DESIGN REVIEW BOARD

WEDNESDAY
February 8, 2017
6:00 PM

DESIGN REVIEW BOARD STAFF REPORT

Carpport profiles

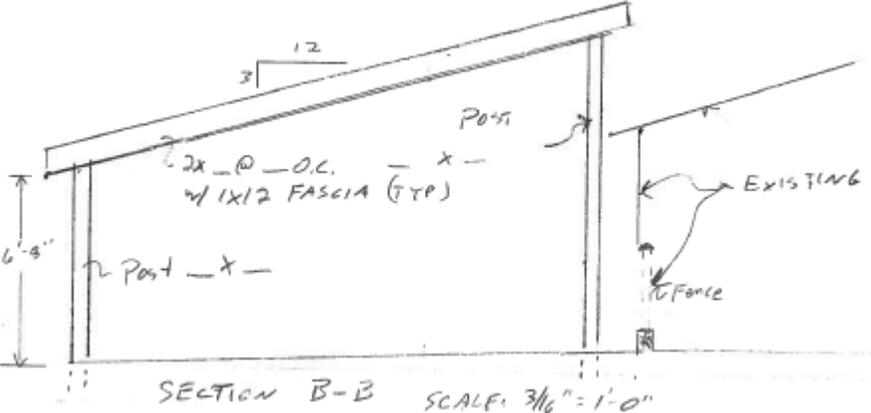
Staff comments: Proposed roof slope appears to be 3:12 on all structures. Shallow roof slopes have been approved in the past for accessory structures and subordinate roof pitches.

Aerial image of property and alley

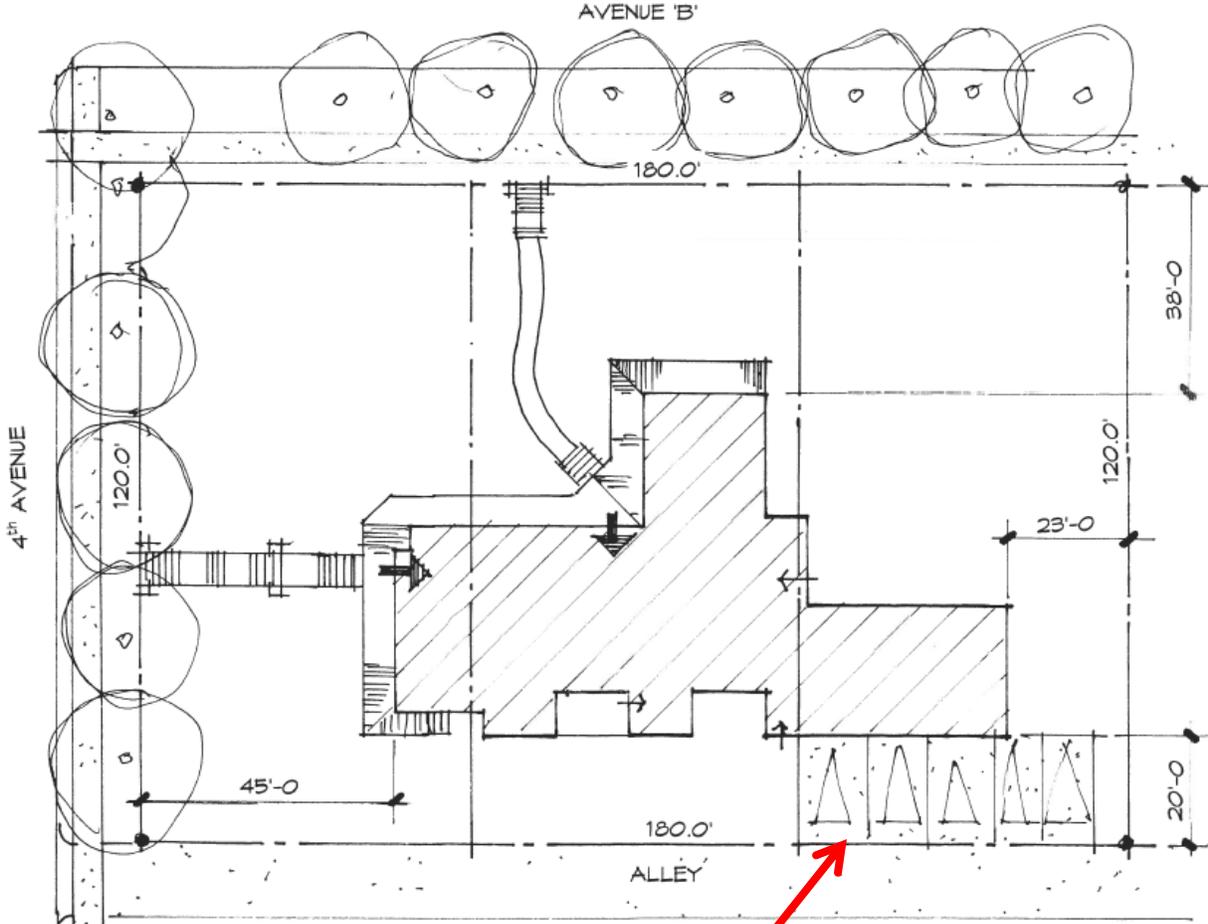
Staff comments: The parking area is proposed behind the building, accessed from the alley. There are several mature trees along Fourth Street that screen parked vehicles from the public street (see image on Page 20).

Rear elevation

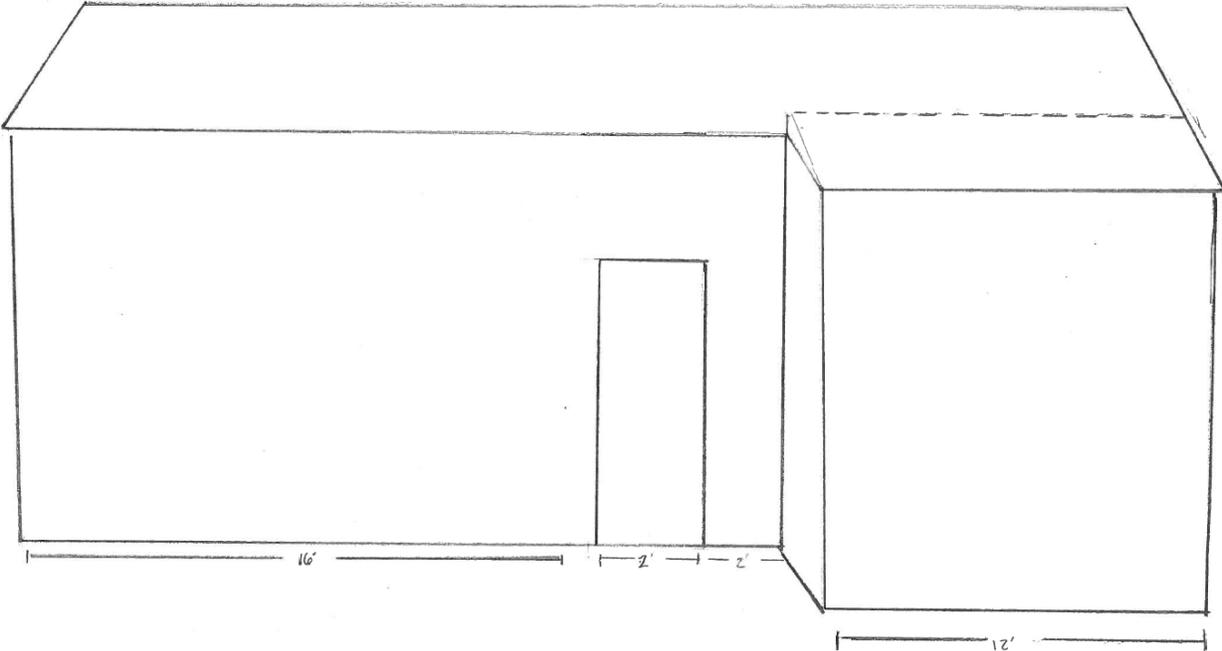
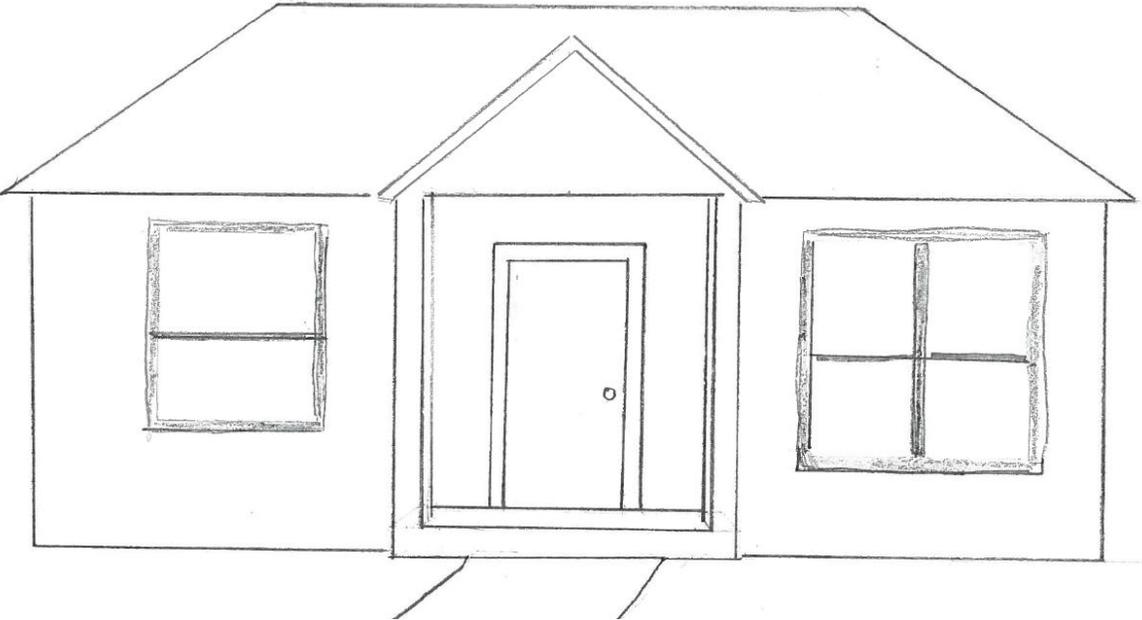
Staff comments: The standard appears to be met, however the Board may wish to discuss the style of the proposed support columns with the applicant. The existing staircase appears to be concrete.
